Access Compliance Report Public Rights-of-Way (Curb Ramps)

Main Street: MARKHAM_LN		Cross Street: DOWNING_ST		Location:	NE
ADA ID: RPAT211103103454	Ramp Type: Type 4 - Parallel	Initial Pass/Fail: Fail	Overall Compliance: No	Severity Score:	16
Codes/Mitigation Info/Possible Solution			Field Measurements/Component Compliance

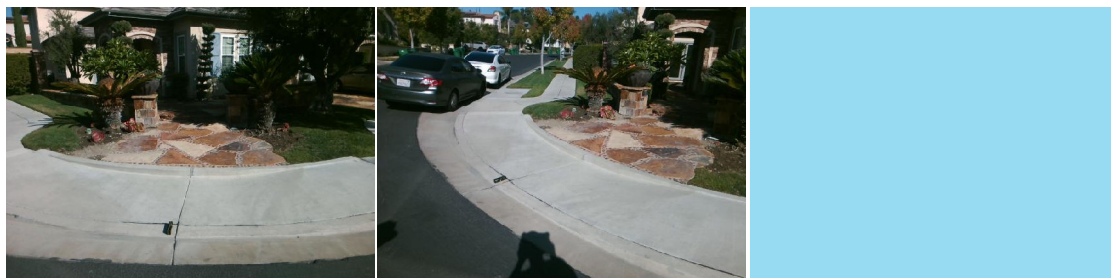
R204.3, R304.3.2, R304.5.3, STD 1115

Remove & Replace Curb Ramp With Two New Directional Ramps or Equivalent.
